Appendix F. Road safety audit response report template for stages 1, 2 and 3 only

Report title:	PROPOSED COMMERCIAL DEVELOPMENT, HOUGHTON MAIN, BARNLEY – PROPOSED GHOST ISLAND PRIORITY JUNCTION Combined Stage 1 and 2 Road Safety Audit
Date:	21st March 2022
Document reference and revision:	RSI-MH-0322-004 Issue 1.1
Prepared by:	Road Safety Initiatives
On behalf of:	Barnley Metropolitan Borough Council

Project:	Houghton Main, Barnley
Report title:	Stage ½ RSA Designers response
Prepared by:	
Name:	Rik Binnersley
Position:	Principal Engineer
Signed:	
Organisation:	RWO Group Leeds
Date:	30.03.2022
Approved by:	
Name:	Andrew Fairburn
Position:	Director
Signed:	
Organisation:	RWO Group Leeds
Date:	30.03.2022

NORTH EAST 0/91 255662			
YORKSHIRE 0113 332050		www.rwo.co.uk RWO GROUP	
Client HARWORTH			
Project HOUGHTON MAIN BARNESLEY			
Title SECTION 278 WORKS TO PARK SPRING ROAD KERBING ARRANGEMENT			
DO NOT SCALE	Scale @ A2: 1:200	Drawn: AD	Checked: AMF
Job No: Y21011	Drawn: D1004	Rev: 4	Date: 07.11.2021

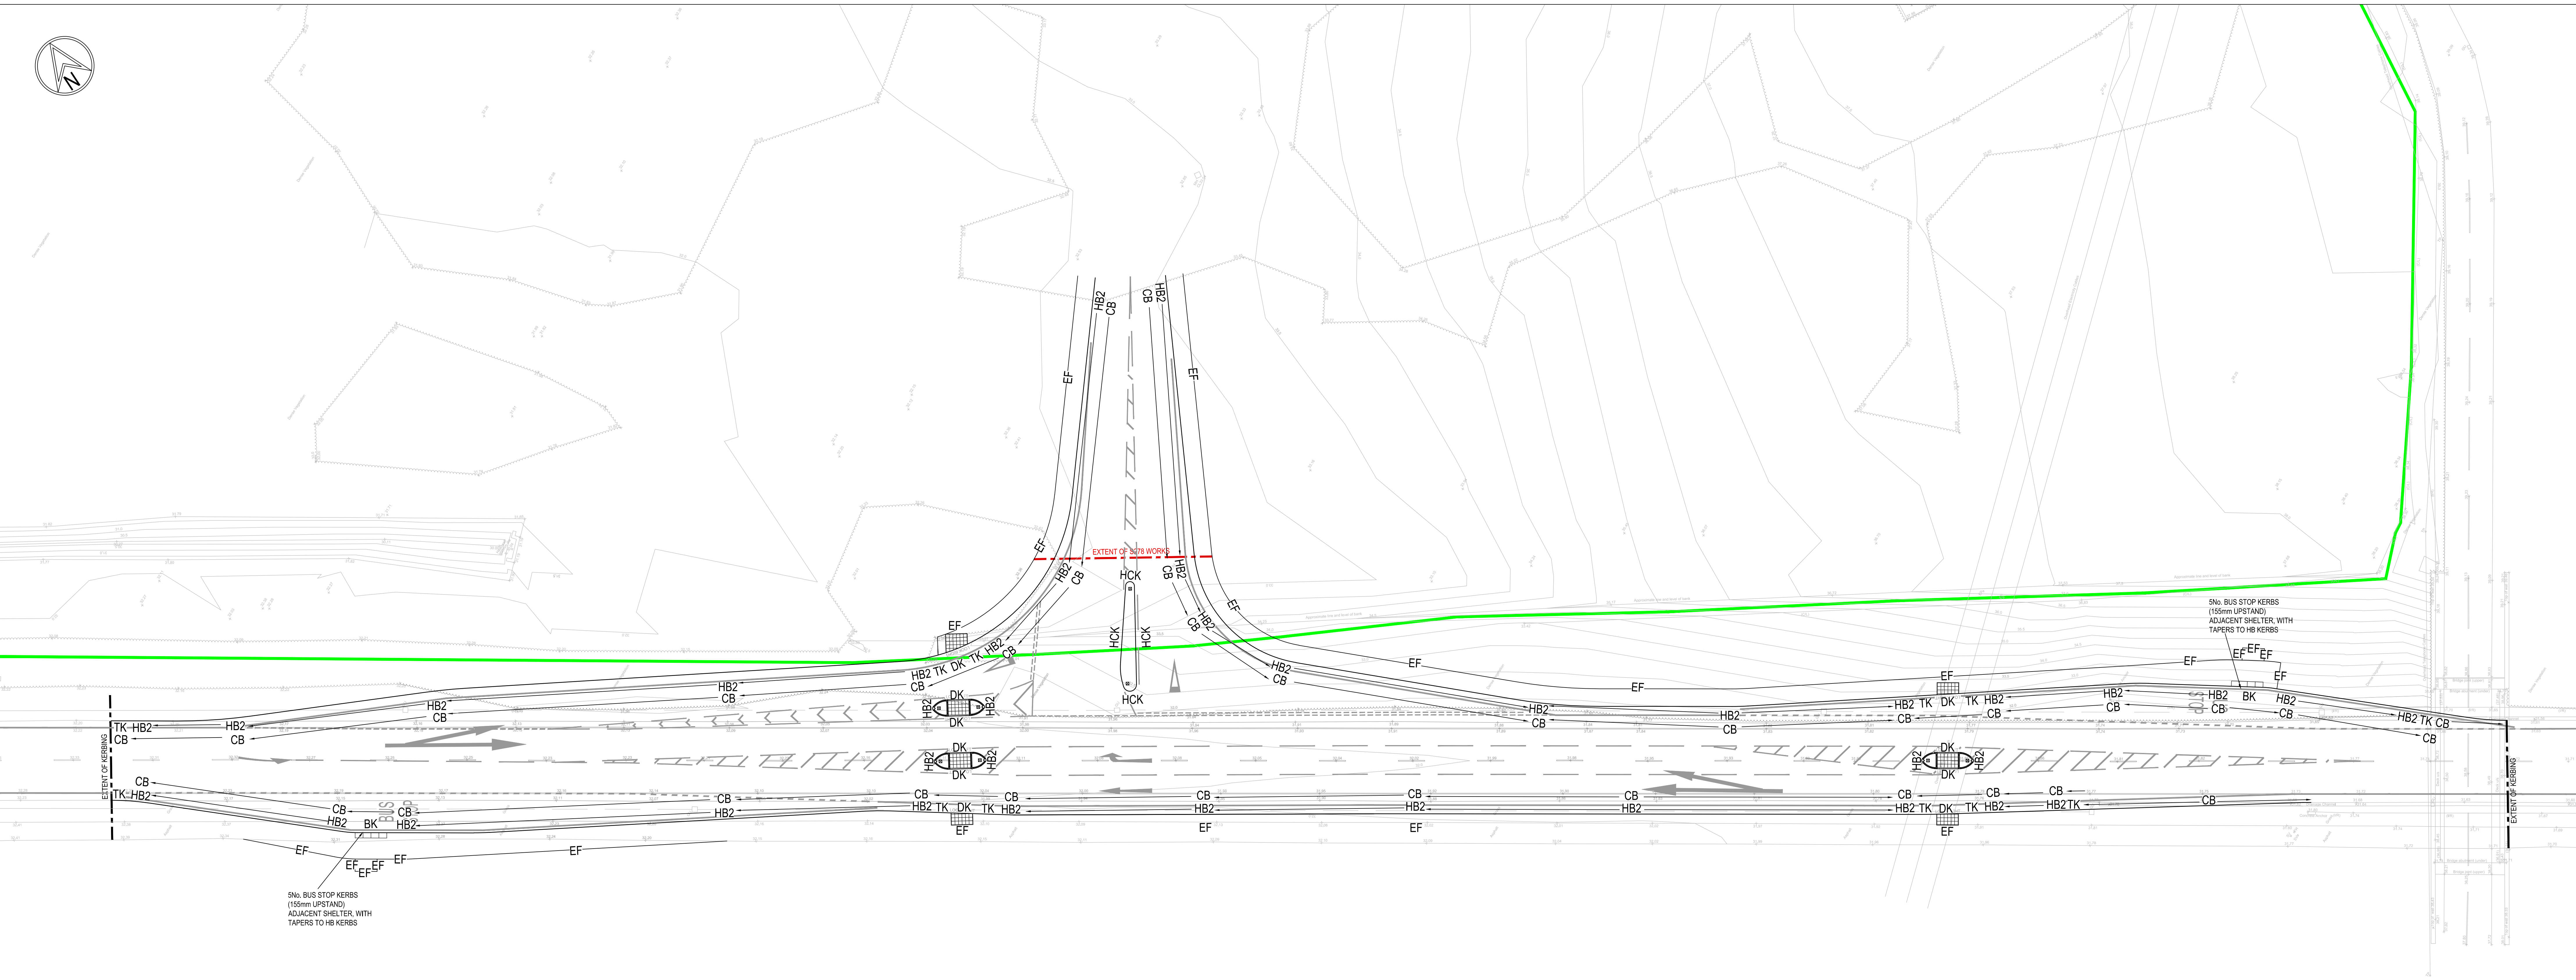
3.3.4 – Inadequate drainage may lead to pedestrian conflicts. It would appear that no drainage is to be provided adjacent to the new kerbline (currently consists of informal 'over the edge' type drainage). The current system results in	It is recommended that adequate drainage is provided.	Agree – At the time of submission of the drawings a drainage scheme for the works was not available. Since this time a preliminary drainage scheme has been produced (Y21011-D1008 – Section 278 Highway Drainage Layout) highlighting how the scheme will be drained. However, it should be noted that the existing ponding issues seem to be caused by vegetation

standing water, which was evident during the site visit. The carriageway is proposed to be widened, which will increase the amount of surface water to be removed and there will be nowhere for it to disperse, which could exacerbate the situation. Drainage issues, with the potential for detritus build-up may lead to ponding in the pedestrian crossing area. This may result in pedestrians crossing at inappropriate locations and increase risk of pedestrian collisions. In addition, during wintry conditions it may lead to pedestrian slips and falls.		growing within the dished channels intended to convey water to the existing highway gullies. Upkeep of these channels to aid free draining of the existing scheme should be undertaken by BMBC.

28.03.2022	SOUTHERN KERB TIE IN AMENDED TO ADD DRAINAGE. CDR:ADK/22	RPS	AMF	4
13.01.2022	BUS STOP ARRANGEMENT AMENDED	RPS	AMF	3
18.11.2021	APPROVED TO ACCORD WITH DESIGN - PARAMETER REVIEW	RPS	AMF	1
07.11.2021	FIRST ISSUE	AD	AMF	1
